GUSSIE NELL DAVIS
RANGERETTE RESIDENCE
KILGORE COLLEGE

Addendum No. 1
to the Proposal Documents for
GUSSIE NELL DAVIS RANGERETTE RESIDENCE
KILGORE COLLEGE
Kilgore, Texas

Addendum No. 2
to the Proposal Documents for
GUSSIE NELL DAVIS RANGERETTE RESIDENCE
KILGORE COLLEGE
Kilgore, Texas

Addendum No. 3
to the Proposal Documents for
GUSSIE NELL DAVIS RANGERETTE RESIDENCE
KILGORE COLLEGE
Kilgore, Texas

I
1.1

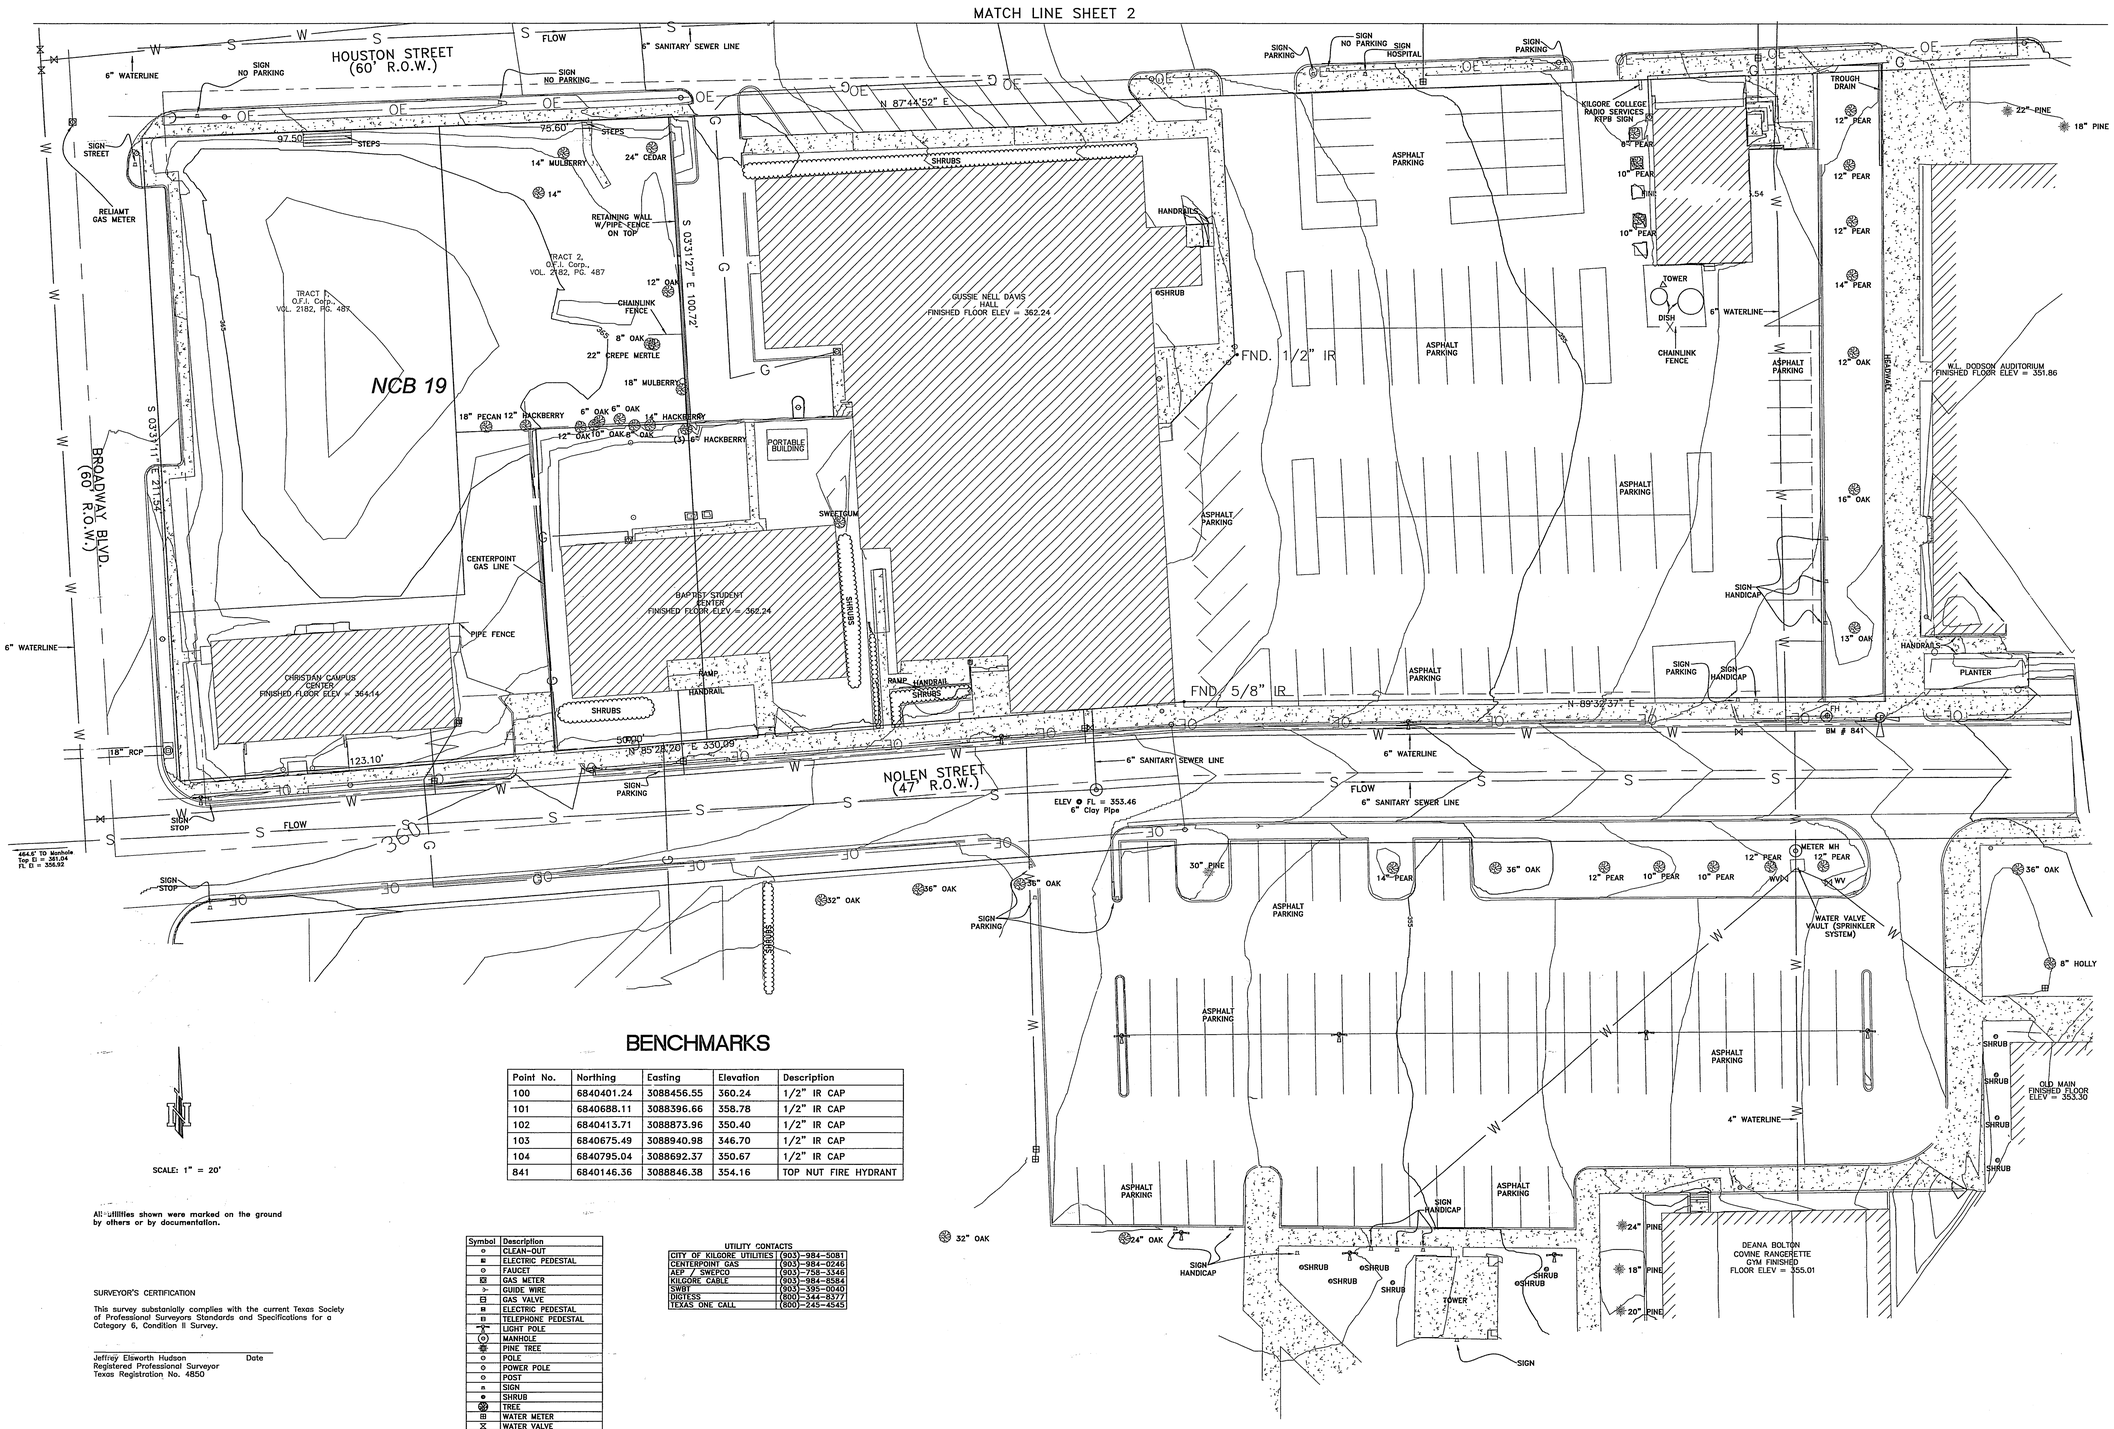
Sheet I1.1
1. Under Interior Signage, Revise Sign Type 6 to be a blank sign (no numbers) and be the same size as Sign Type 5 (8" tall by 6 ½" wide). This sign is a blank plate for the mounting on back of glass.
2. Under sheet title edge, sheet contents, delete reference to "Exterior Signage".

STAGING SITE PLAN

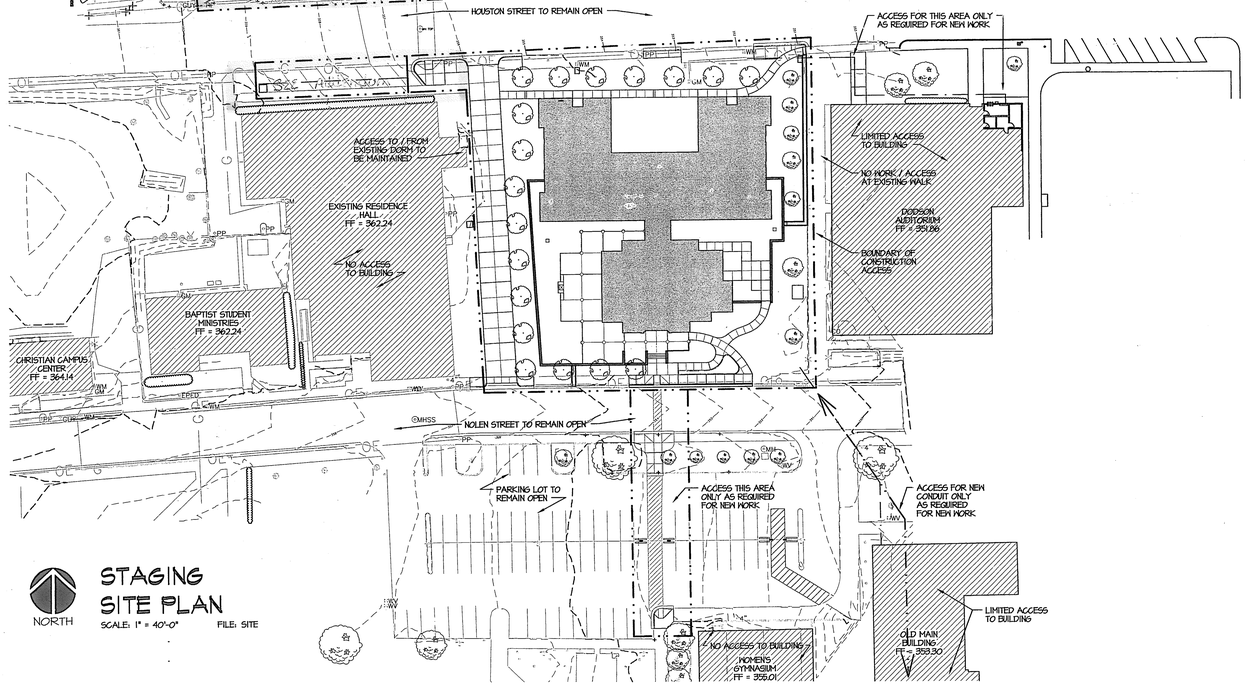
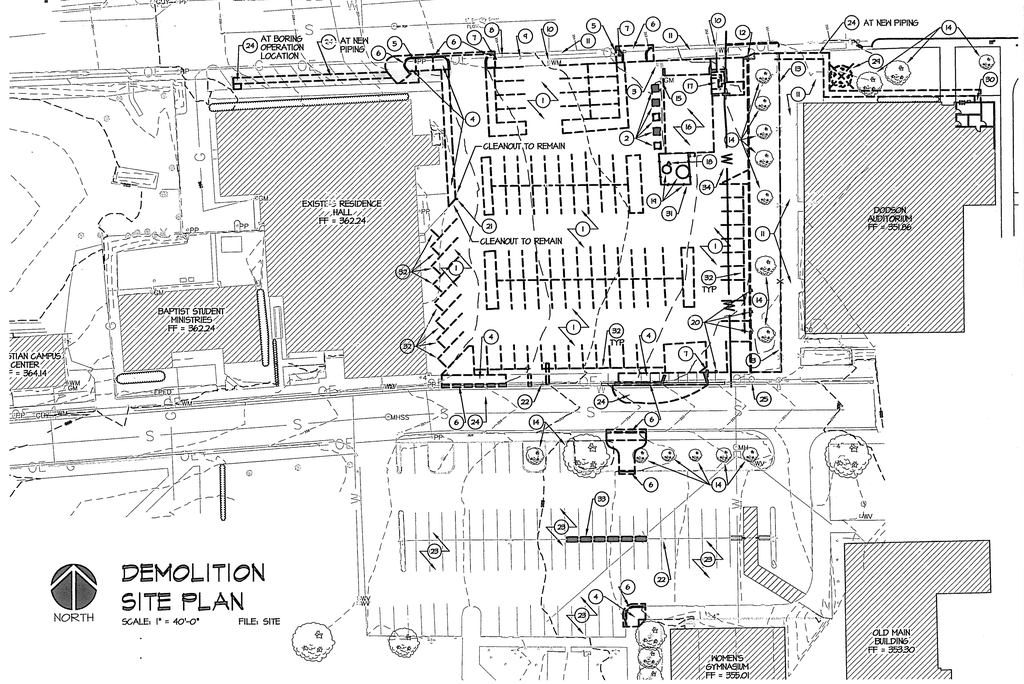
Sheet A1.0
1. Staging Plan, General Notes, note 1, delete the partial sentence in the parenthesis.
2. Detail ST01, note the thickened edge of the concrete at the expansion joint will be the same as ST02.
3. Detail ST03, revise the depth of the sawn joint to be 1" at 4" concrete flatwork and 1 ½" at 6" paving.
4. Demolition Site Plan, North Site (north of Houston Street), note the requirement for removal of existing concrete paving is as shown and as required for the installation of all utilities (refer MEP).
5. Demolition Site Plan, South Site (south of Houston Street), off Houston Street parking, note the requirement for removal of existing paving is as shown and as required for the installation of all utilities (refer MEP).

Sheet A1.1

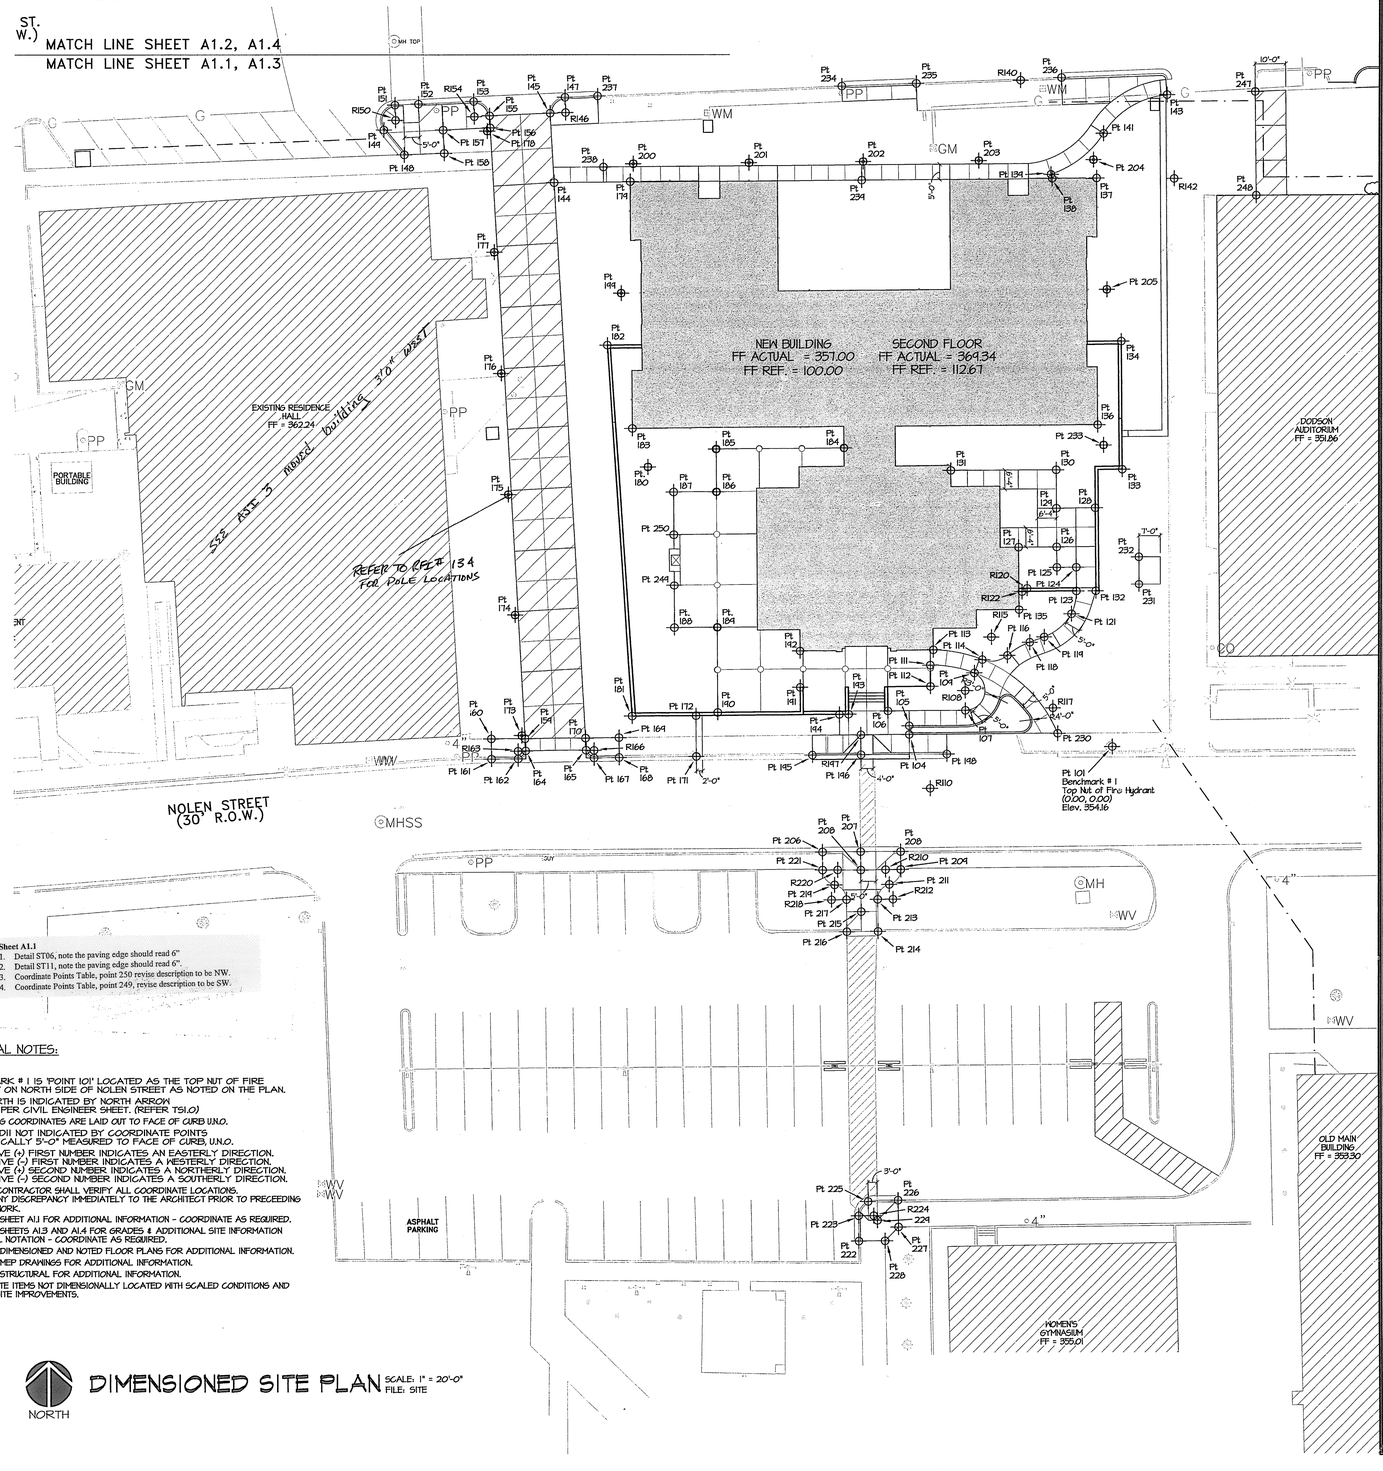
1. Detail ST06, note the paving edge should read 6"
2. Detail ST11, note the paving edge should read 6".
3. Coordinate Points Table, point 250 revise description to be NW.
4. Coordinate Points Table, point 249, revise description to be SW.

Sheet A1.3

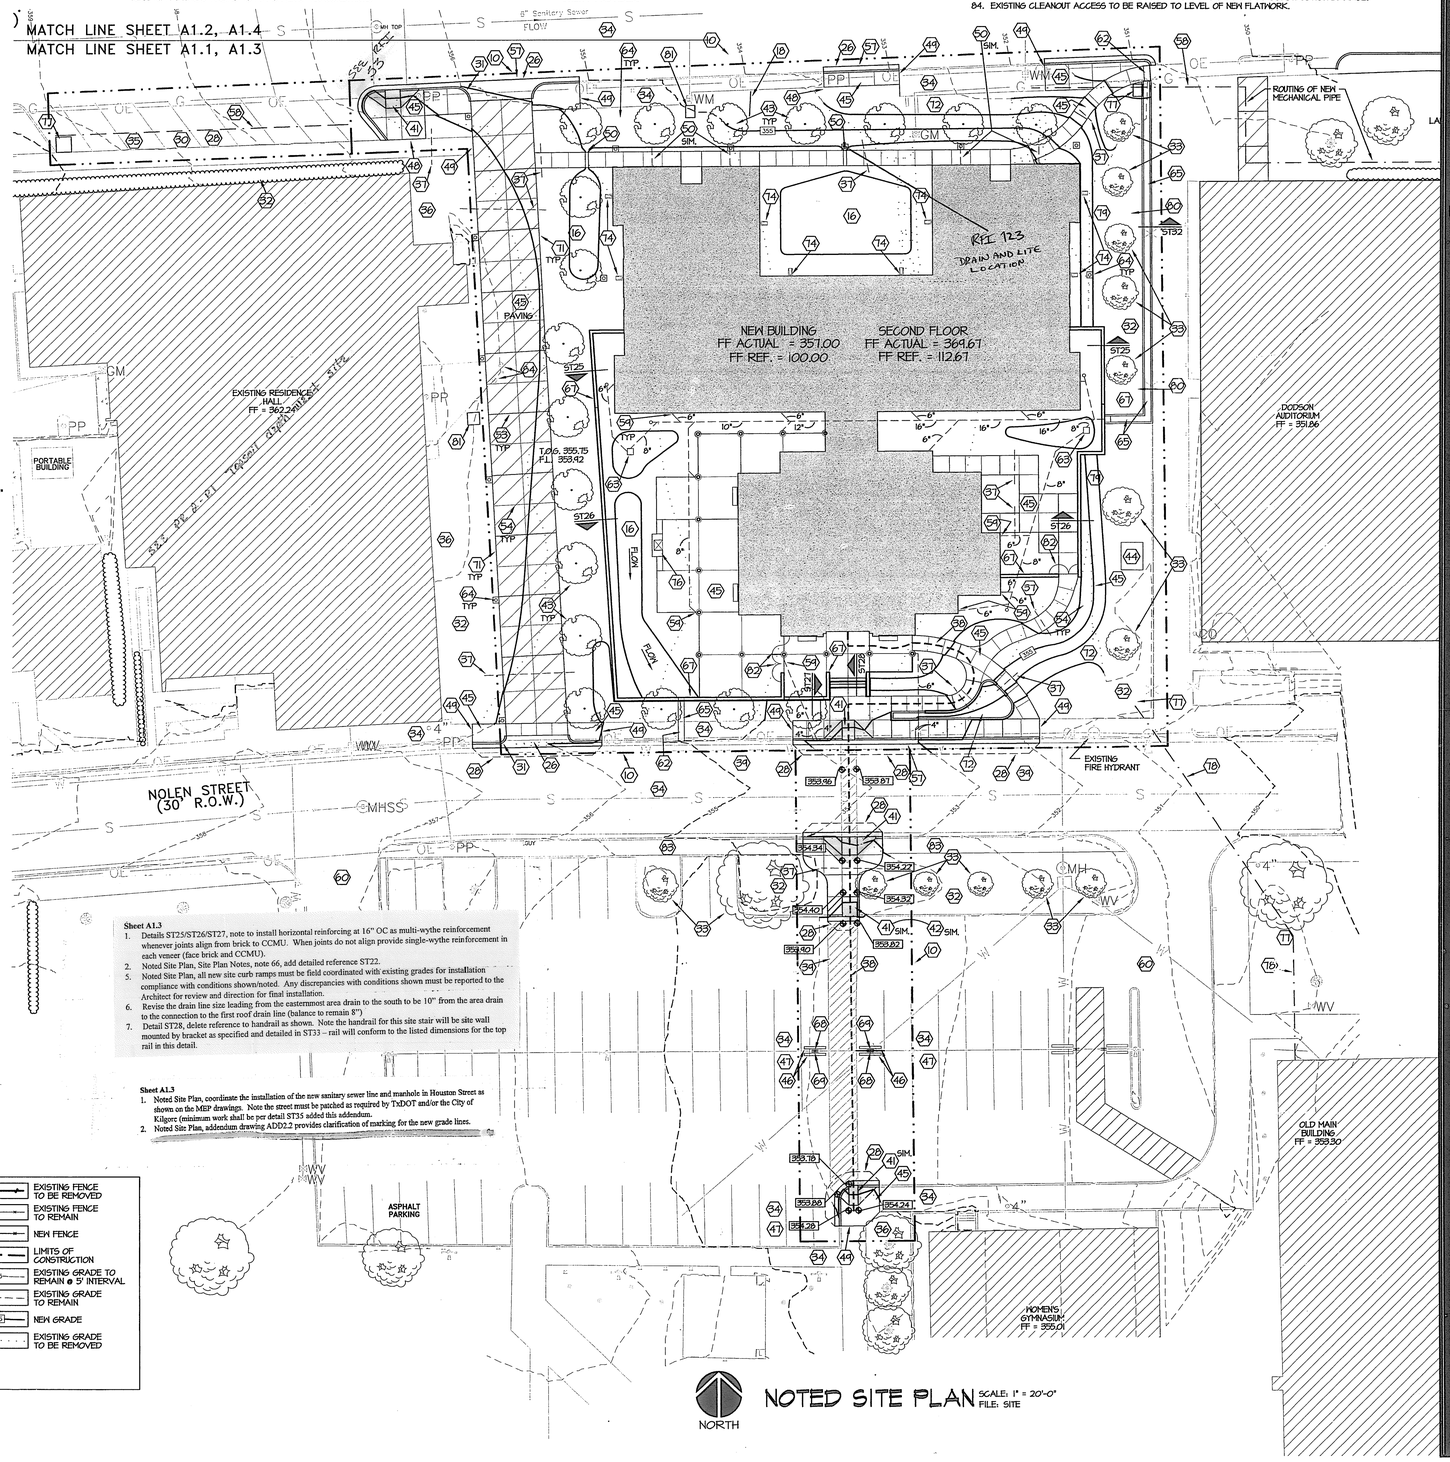
1. Details ST25/ST26/ST27, note to install horizontal reinforcing at 16" OC as multi-wythe reinforcement wherever joints align from brick to CCMU. When joints do not align provide single-wythe reinforcement in each veneer (face brick and CCMU).

7. Detail ST28, delete reference to handrail as shown. Note the handrail for this site stair will be site wall mounted by bracket as specified and detailed in ST33 – rail will conform to the listed dimensions for the top rail in this detail.

1. Noted Site Plan, coordinate the installation of the new sanitary sewer line and manhole in Houston Street as shown on the MEP drawings. Note the street must be patched as required by TxDOT and/or the City of Kilgore (minimum work shall be per detail ST35 added this addendum.
2. Noted Site Plan, addendum drawing AD20.2 provides clarification of marking for the new grade lines.

NOTED SITE PLAN

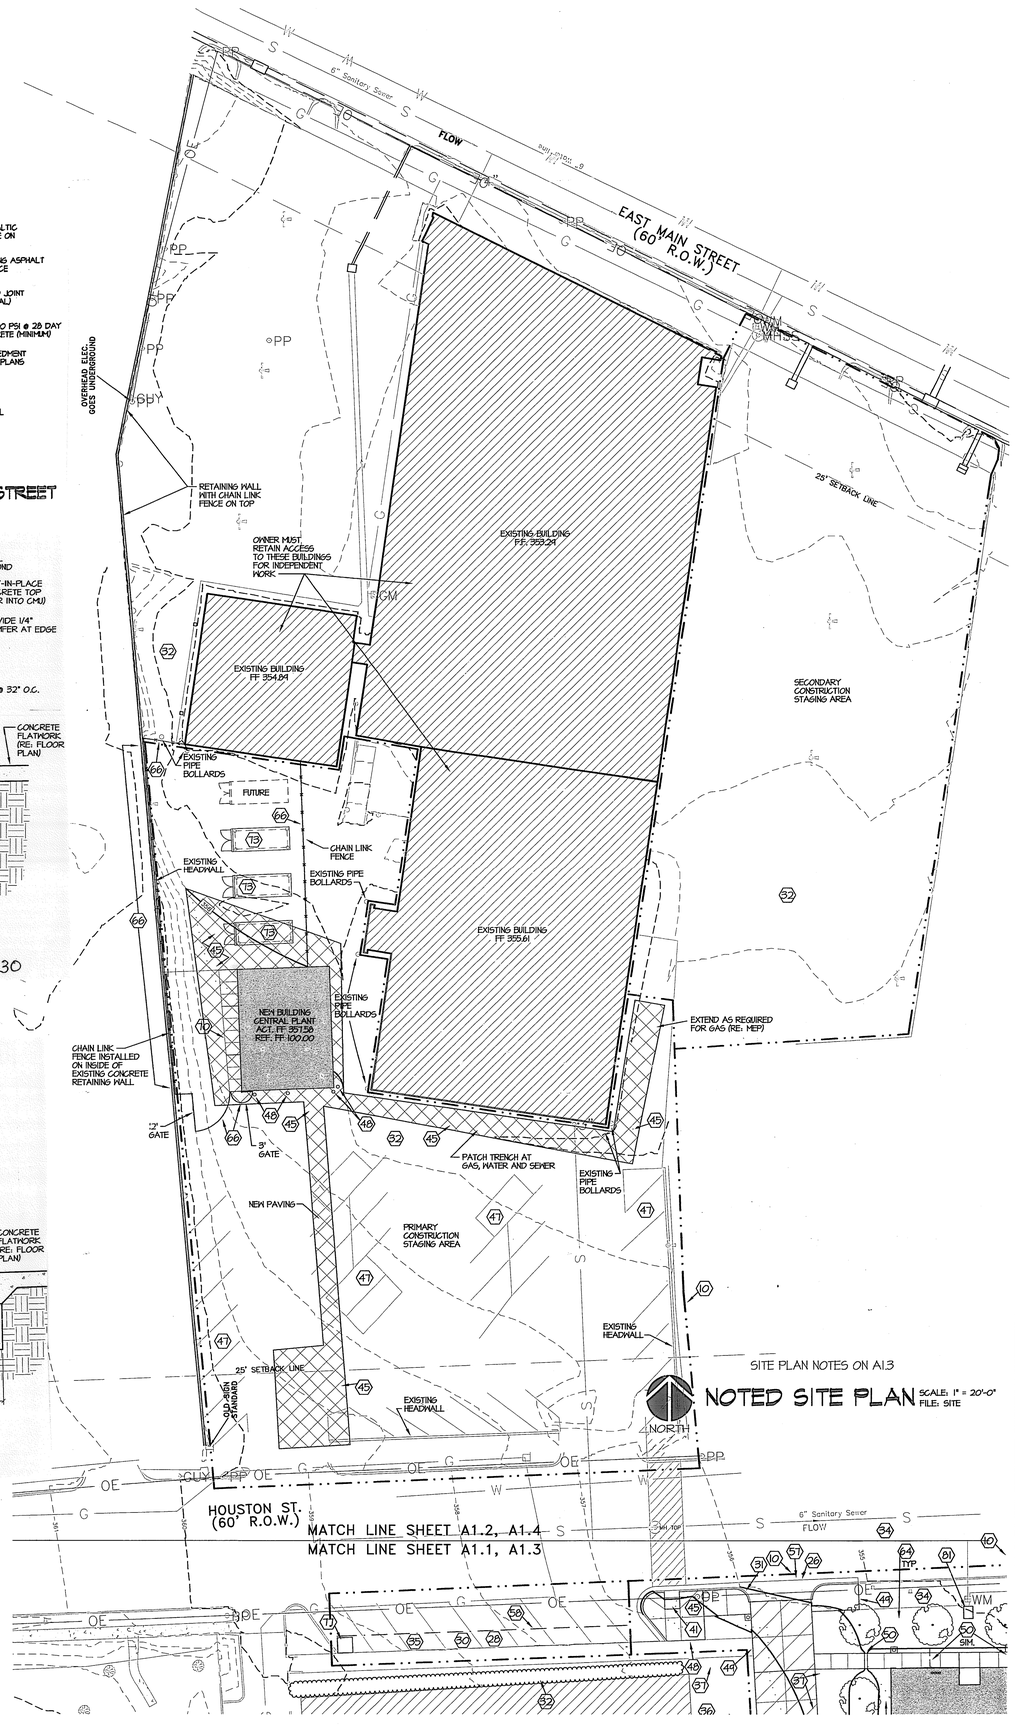
Sheet A1.4
1. Detail ST29, delete this detail and replace with the detail included this addendum on ADD1.2.
2. Detail ST30, delete this detail and replace with the detail included this addendum on ADD1.3.
3. Detail ST31, delete this detail and replace with the detail included this addendum on ADD1.4.
4. Detail ST32, revise the depth of the valley gutter to be 8".
5. Noted Site Plan, note the requirement for new paving will match replacement required by the removal of existing concrete paving as required for the installation of all utilities (refer MEP).

Sheet A1.4
1. Noted Site Plan, coordinate the installation of the electrical transformer with pad as shown on the MEP drawings. Add two (2) bollards at this transformer per ST18 with installation as directed by the Architect.
